# Access Compliance Report

## Public Rights-of-Way

### (Curb Ramps)

Intersection ID: 48946	Main Street: DAVID_JENNINGS_AV	Cross Street: MITCHELL_GRANT_WY	Location: N
ADA ID: F956DEA47506	Ramp Type: Combination1	Initial Pass/Fail: Fail	Overall Compliance: No
Severity Score: 33.75			
Codes/Mitigation Info/Possible Solution		Field Measurements/Component Compliance

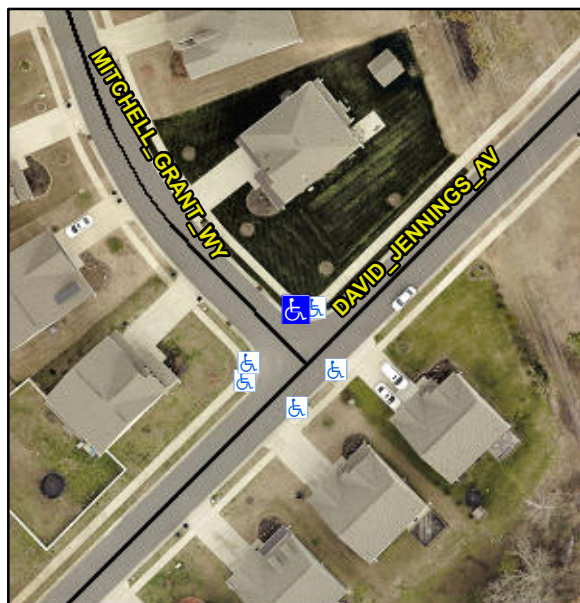
**CURB WIDTH 38.5**

**Not Found, R304.5.1, R304.2.2, R304.5.3, R304.3.2**

**Remove & Replace Entire Ramp.**
